ARBORICULTURAL IMPACT ASSESSMENT

REPTILE & AMPHIBIAN CONSERVATION CENTRE (RACC)

Prepared for:

Paul De Alwis (Project Manager)
Taronga Conservation Society Australia

Figure 3

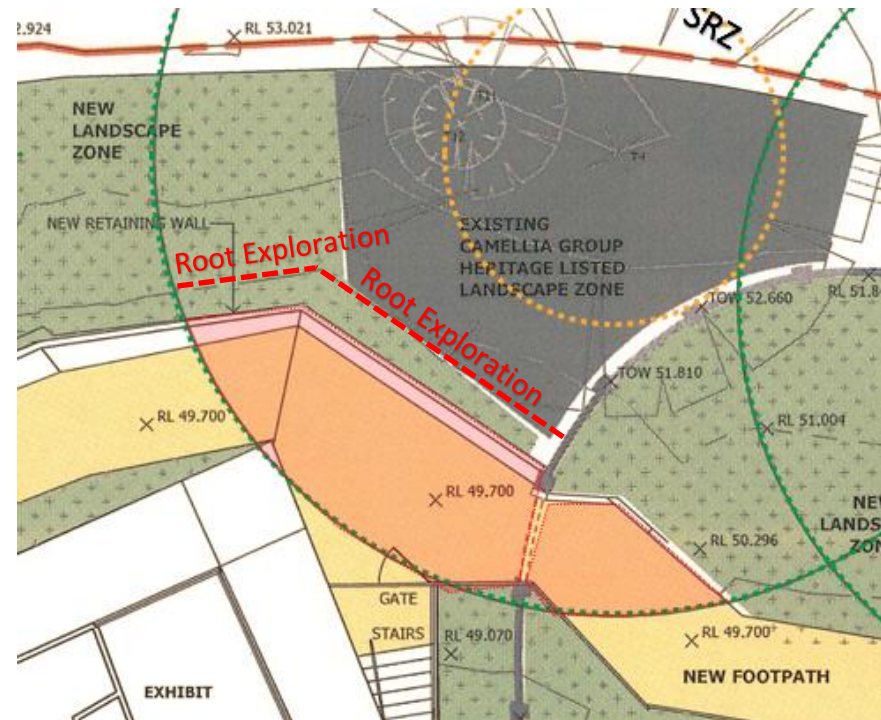
The proposed retaining wall within the TPZ of this tree is supported, however non-destructive root exploration to assess the extent of tree roots in this location is required. The following factors contribute to this:

The proposed retaining wall is a major encroachment of 11.4% into the TPZ of the tree with a significant cut. The supplied plans do not show a proposed batter for the cut or if the cut will be piled.

The supplied plans show that '90 diameter UPVC agricultural drain' is to be installed north of the proposed retaining wall further increasing the major encroachment to an estimated 14.5% encroachment, if the trench is 500mm in width.

Non-destructive root exploration should be conducted as indicated within Figure 3, 500mm further into the TPZ from the proposed retaining wall.

Non-destructive root exploration should be conducted by an experienced AQF-5 Arborist to a depth of 800mm.

Where tree roots greater than 50mm diameter are encountered and the project Arborist finds that root pruning will have an adverse effect on the subject tree the design in this location shall be modified.

Figure 4

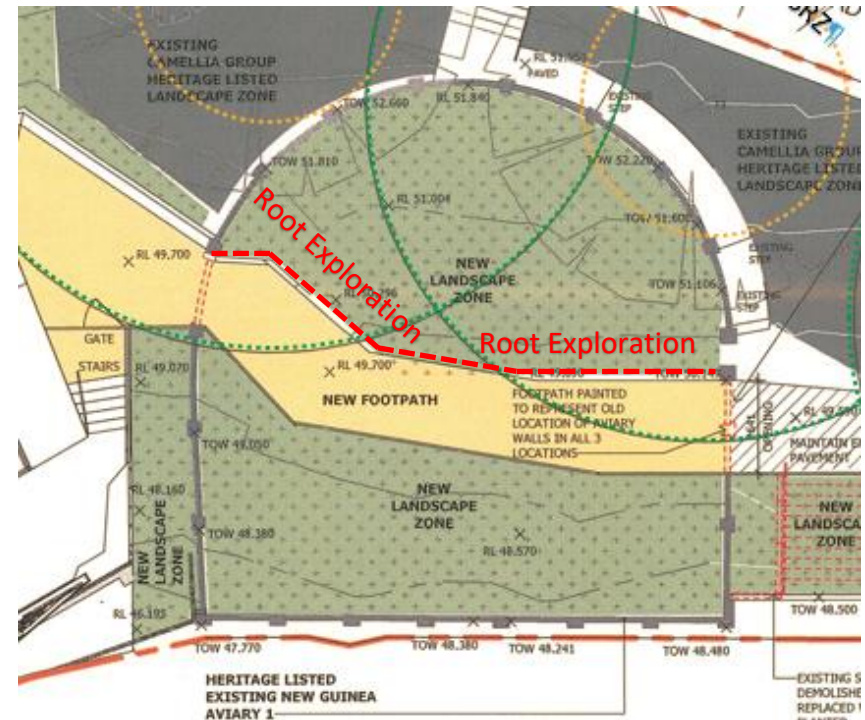
The proposed path within the TPZ of these trees is supported, however requires non-destructive root exploration to assess the extent of tree roots in this location.

The proposed path contributes to the major encroachment of 11.4% into the TPZ of tree 4 and a minor encroachment into the TPZ of tree 3. Whilst there may not be tree roots inside the heritage aviary this needs to be confirmed through non-destructive root exploration.

Non-destructive root exploration should be conducted as indicated within Figure 4, 500mm further into the TPZ from the proposed retaining wall.

Non-destructive root exploration should be conducted by an experienced AQF-5 Arborist to a depth of 500mm.

Where tree roots greater than 50mm diameter are encountered and the project Arborist finds that root pruning will have an adverse effect on the subject tree the design in this location shall be modified to:

5.3.2.2.4.1 Pier and beam construction with no strip footings.

8.6.1 General Arrangement Plan -Entry + Landscaping mark-up showing proposed impacts to tree 1-6 (TPZ & SRZ to scale)

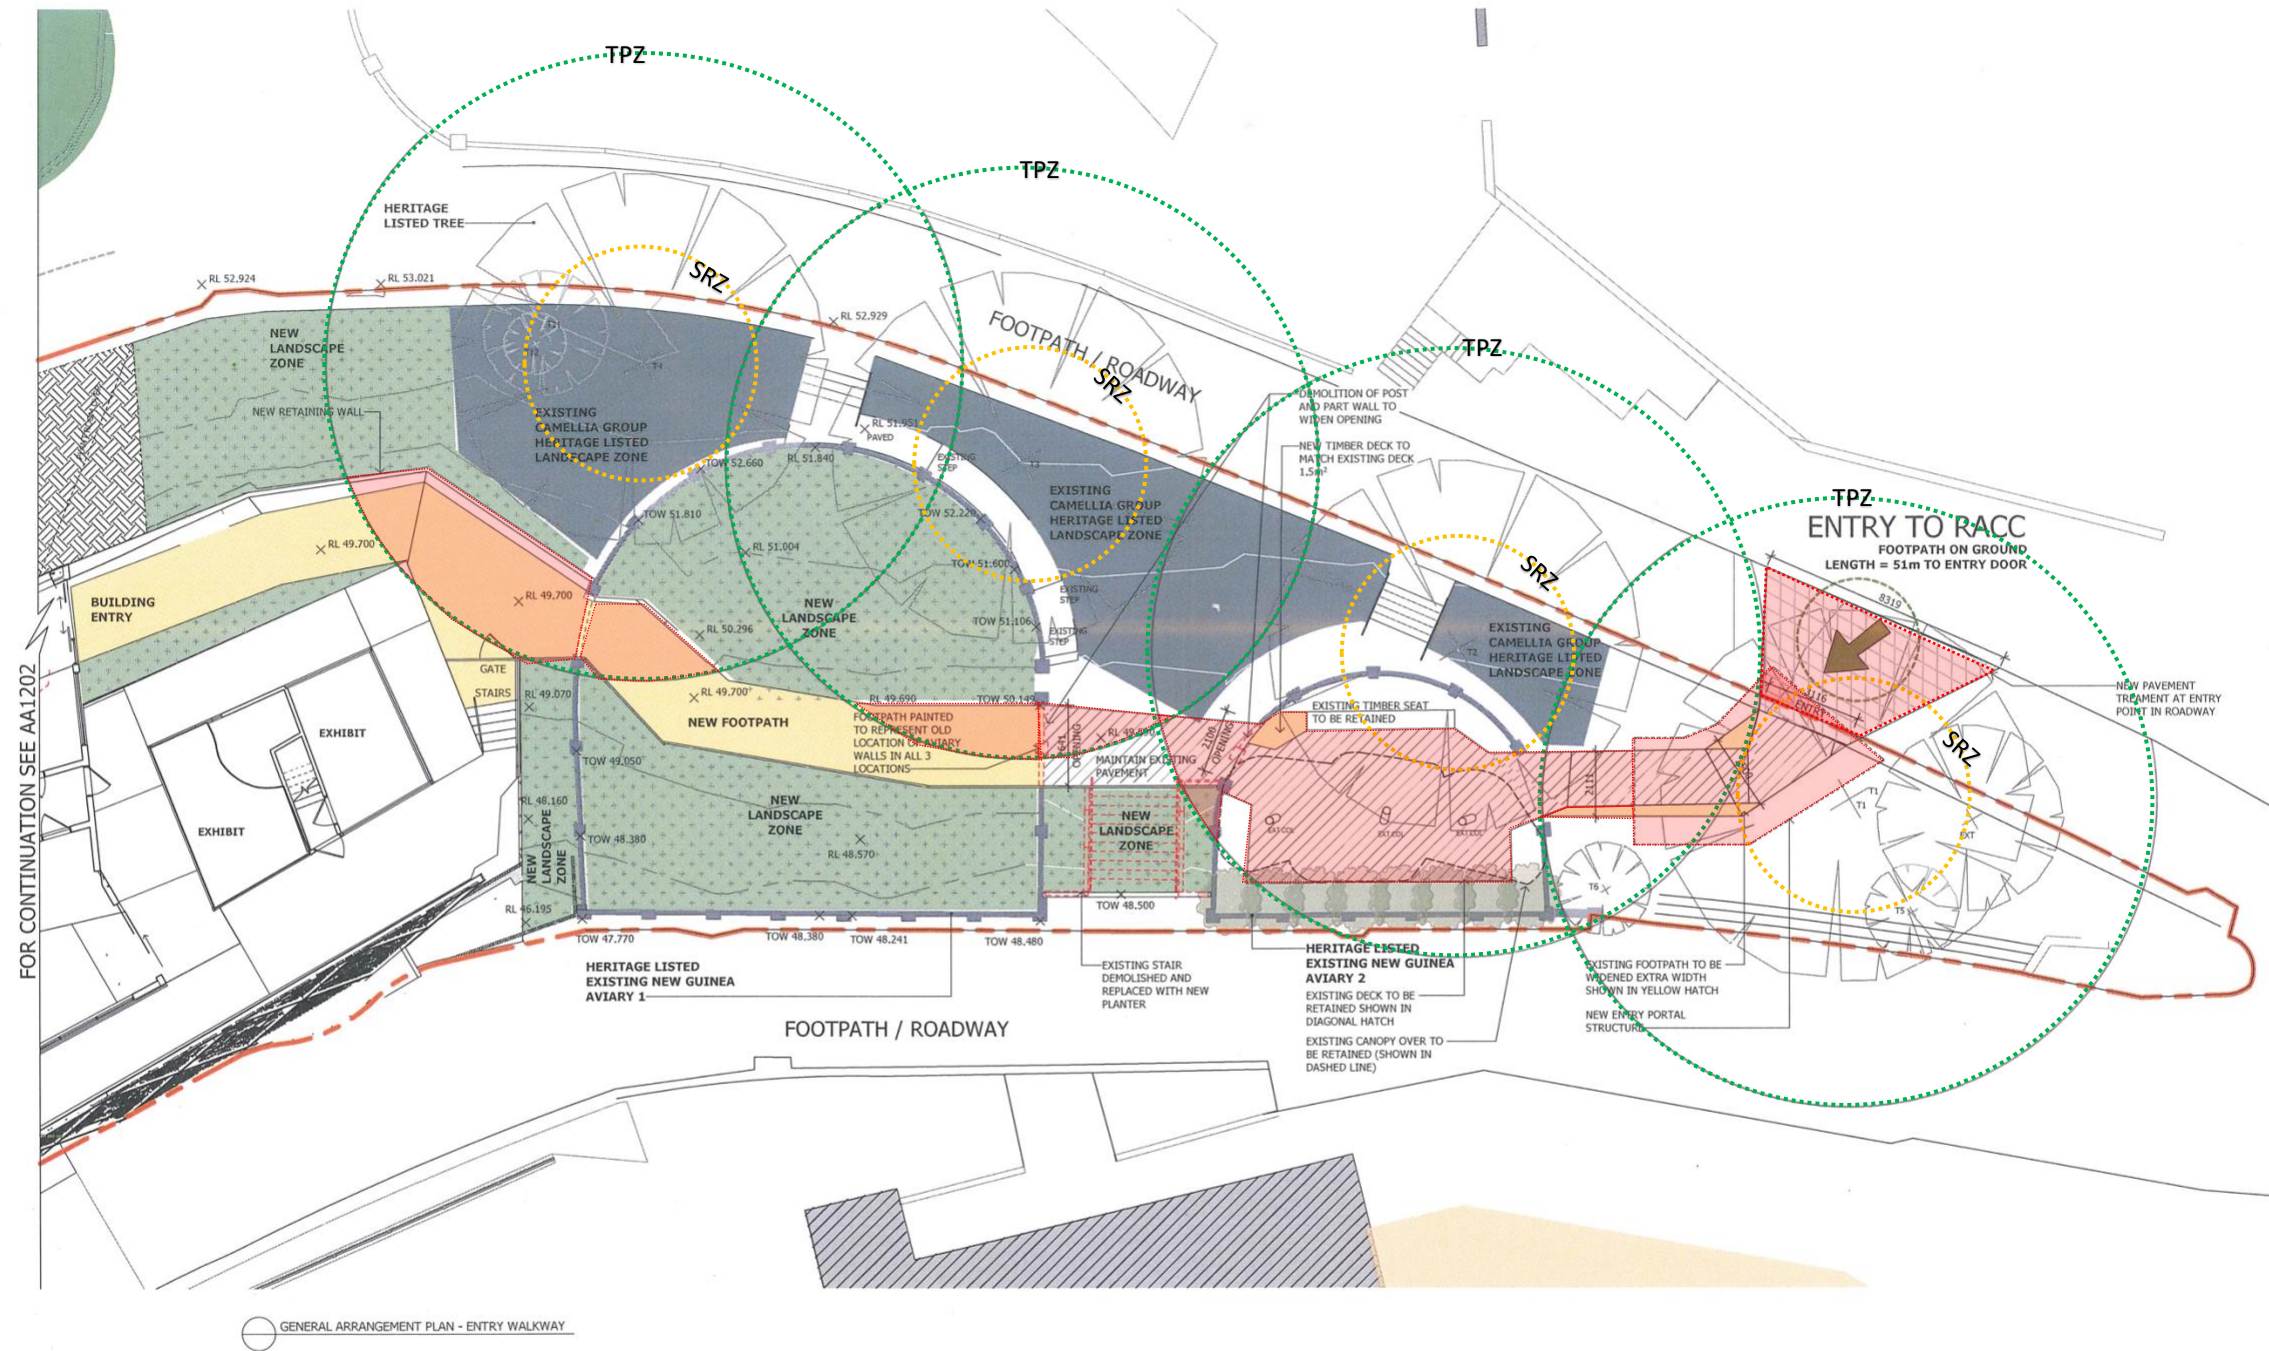
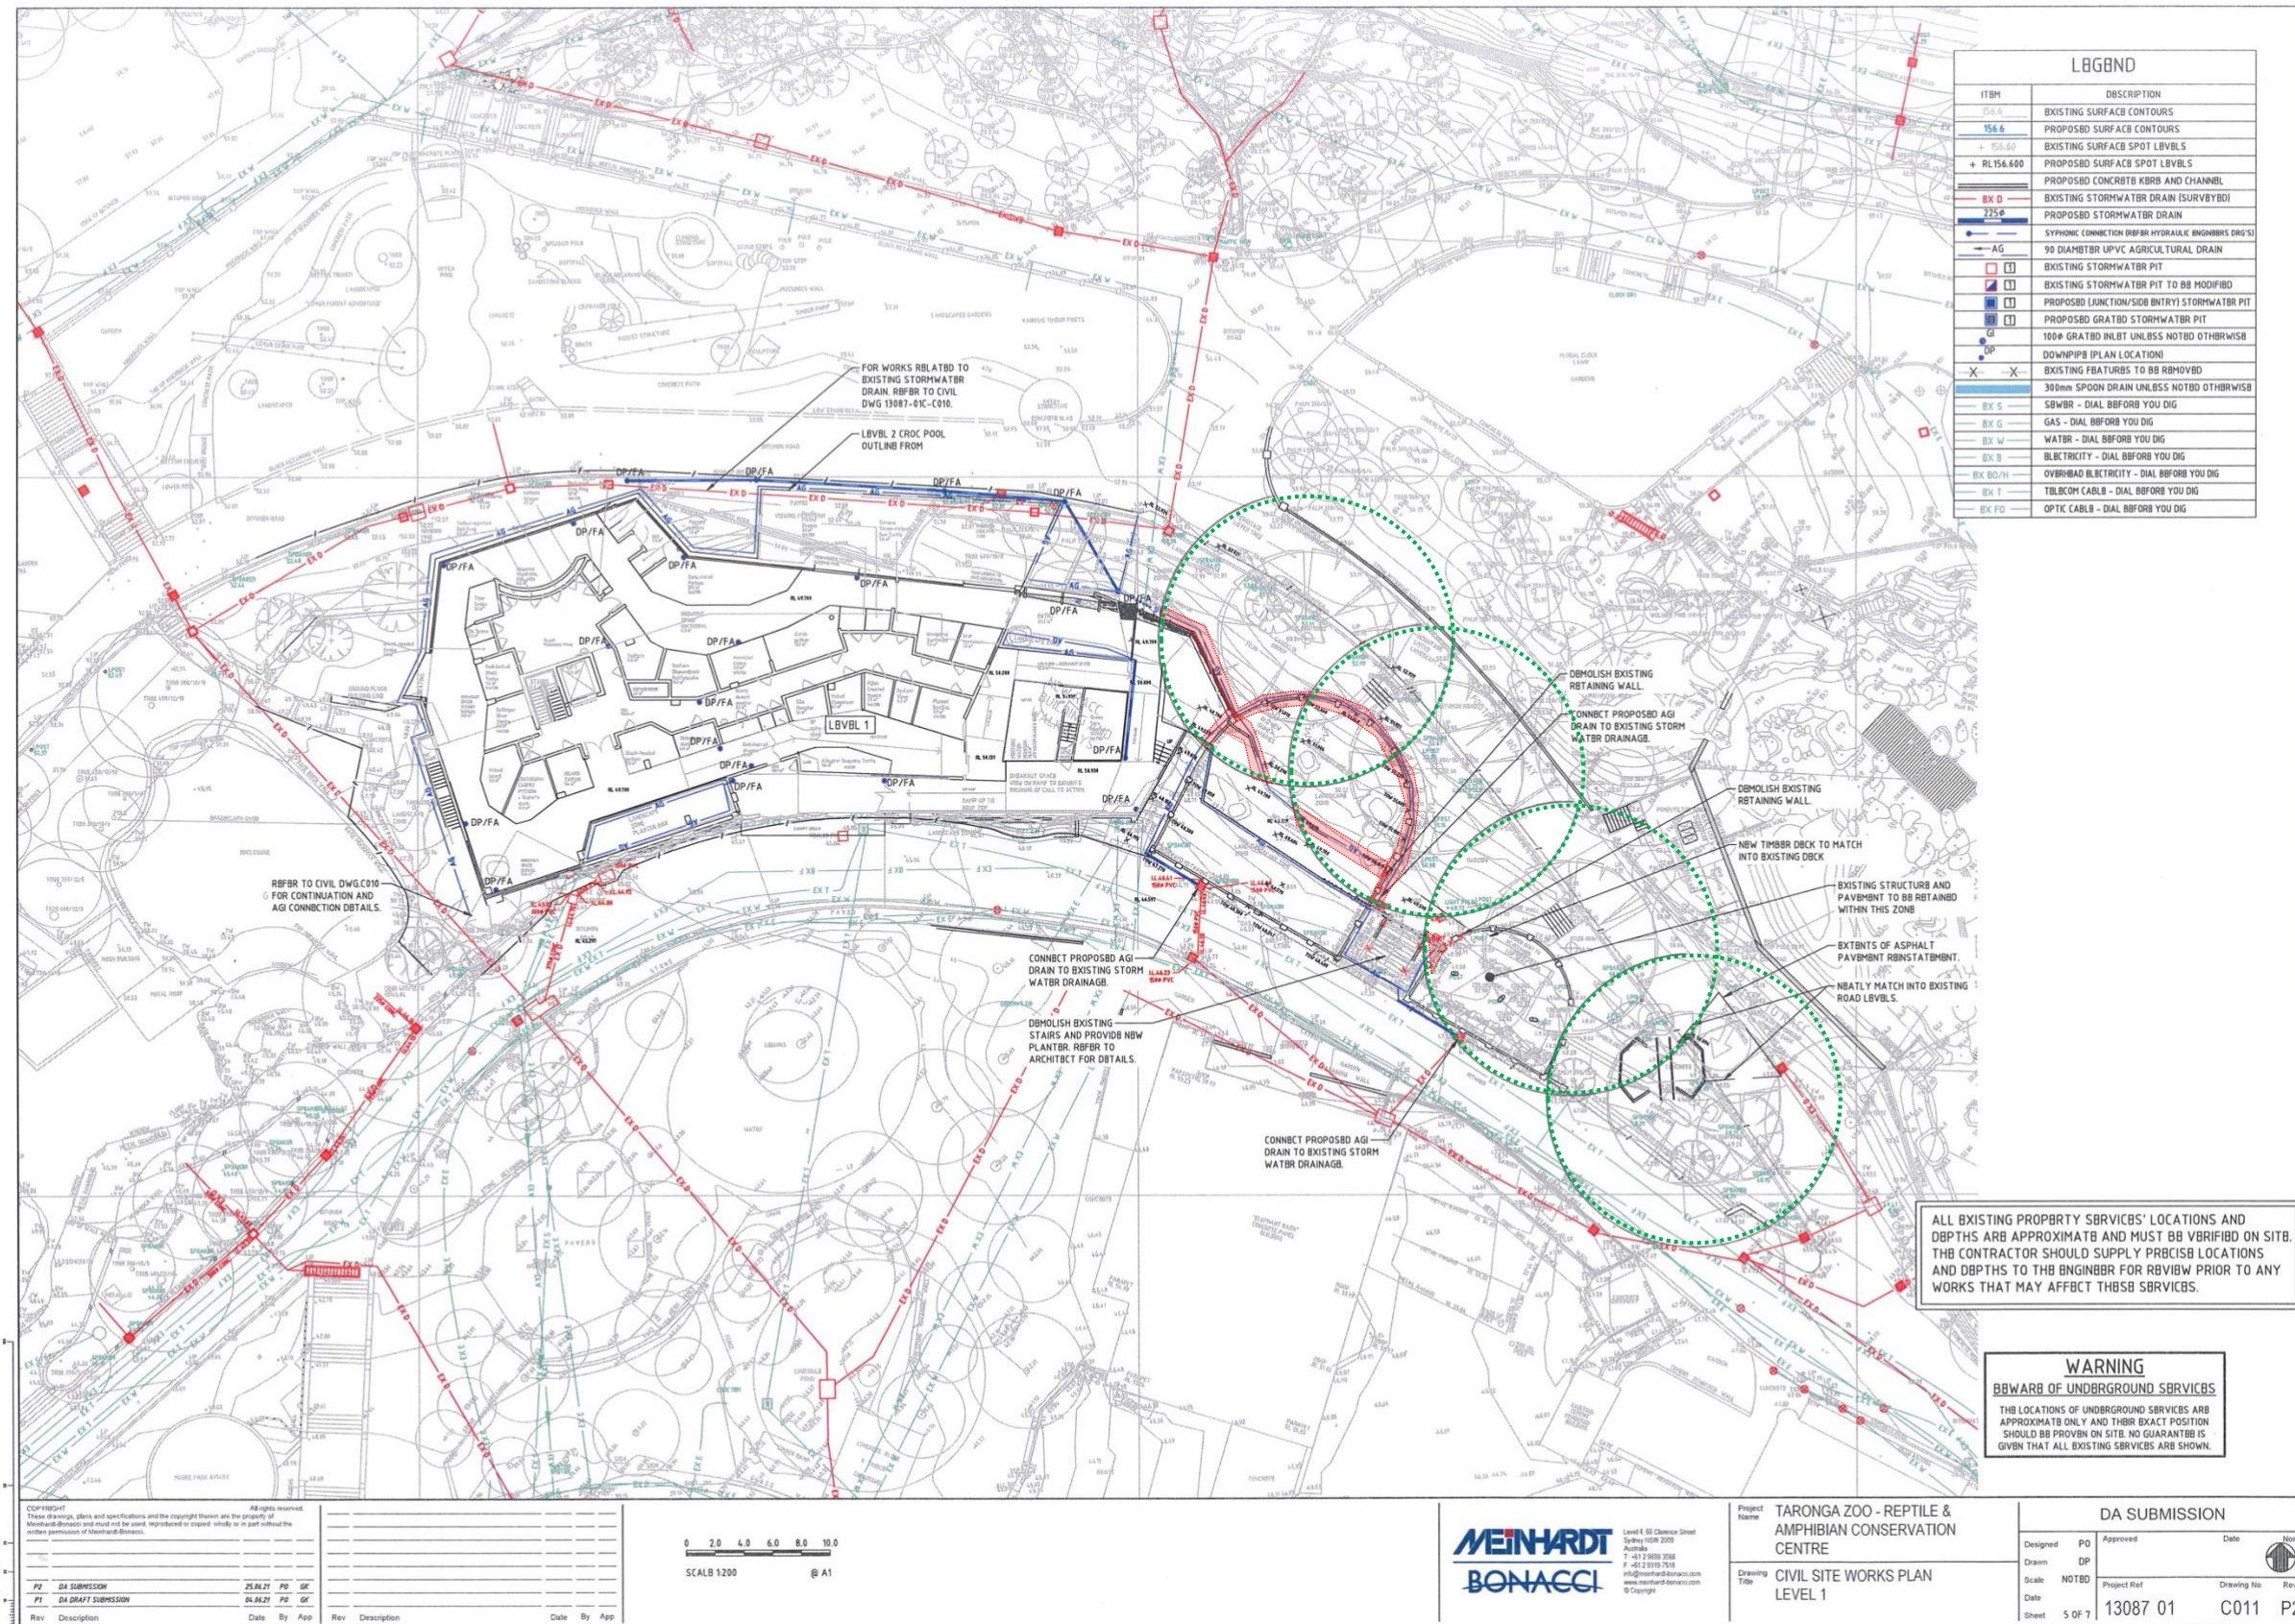
Proposed works in the SRZ & TPZ include:

- Demolition of the existing stairs and pavement,
- New pavement treatment,
- Existing footpath to be widened, and
- New entry portal structure widening of the existing path (deck).

Proposed works within the SRZ & TPZ include:

- Demolition of post and part of the existing Heritage Aviary walls,
- New timber deck to match existing deck,
- Widening of the existing path (deck), and
- Existing stairs to be demolished and replaced with a new planter with a new landscaping zone.

Proposed works within the SRZ & TPZ include:

- Demolition of post and part of the existing Heritage Aviary walls,
- Trench excavation and Installation of 90 diameter UPVC agricultural drain north of the existing aviary wall and north of the proposed new footpath,
- Demolition of tree 7,
- Demolition of a rock structure, and
- Construction of a new path

Proposed works within the SRZ & TPZ include:

- Demolition of part of the existing Heritage Aviary walls,
- Demolition of a rock structure,
- Excavation and construction of a retaining wall, and
- Trench excavation and Installation of 90 diameter UPVC agricultural drain north of the existing aviary wall, north of the proposed new footpath and north of the proposed retaining wall.
